DEVELOPMENT REVIEW BOARD REPORT

CASE NUMBER/ PROJECT NAME	63-DR-2005 Crown West Pinnacle Offices		
LOCATION	23733 North Scottsdale Road		
REQUEST	Request site plan and elevations approval for a new parking garage and three (3) new office buildings.		
OWNER	Crown West Realty 602-288-3836	ENGINEER	Hunter Engineering 480-991-3985
ARCHITECT/ DESIGNER	Cawley Architects Inc. 602-393-5060	APPLICANT/ COORDINATOR	Paul Devers Cawley Architects Inc. 480-237-3700
BACKGROUND	<p>Zoning.</p> <p>This site is zoned Central Commercial, Environmentally Sensitive Lands District (C-2 ESL), which allows a large variety of commercial activities designed to serve the community.</p> <p>Context.</p> <p>The 8.4-acre site is located north of East Pinnacle Peak Road on the east side of North Scottsdale Road. The site abuts and connects with an existing commercial shopping center to the south, and abuts existing single-family homes to the east and north. To the west of North Scottsdale Road is vacant land located within the jurisdiction of the City of Phoenix.</p> <p>In 1987, the Development Review Board approved an office complex master plan for the property that included an initial phase consisting of the ex

PROPOSED PARKING GARAGE

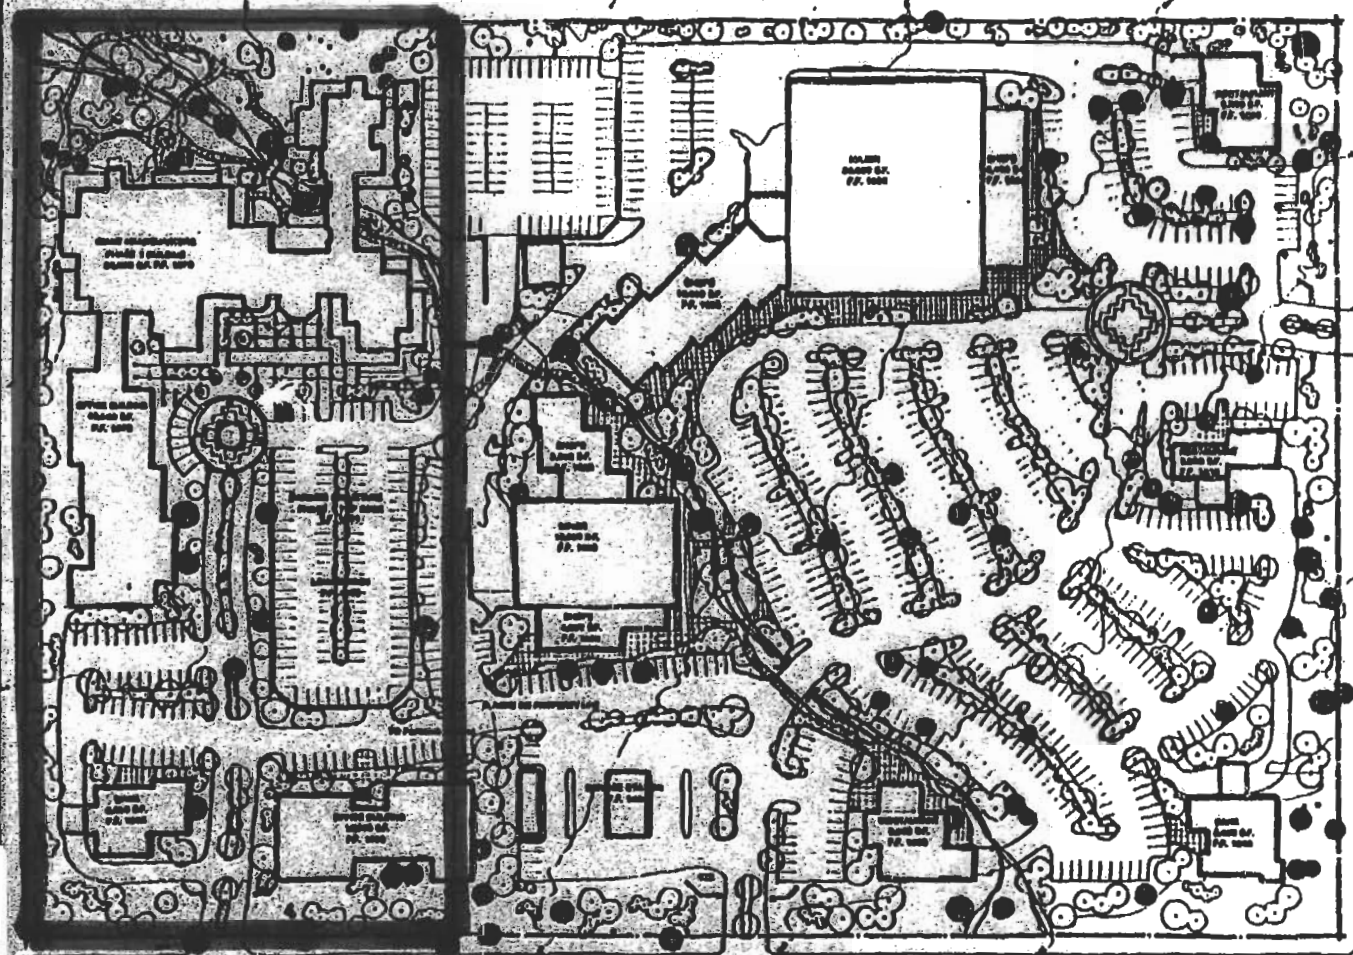
34. The developer shall design and construct a connection between the drive aisles to the north of the proposed parking structure located in the south east corner of the site, for continuous traffic movement within the parking lot.
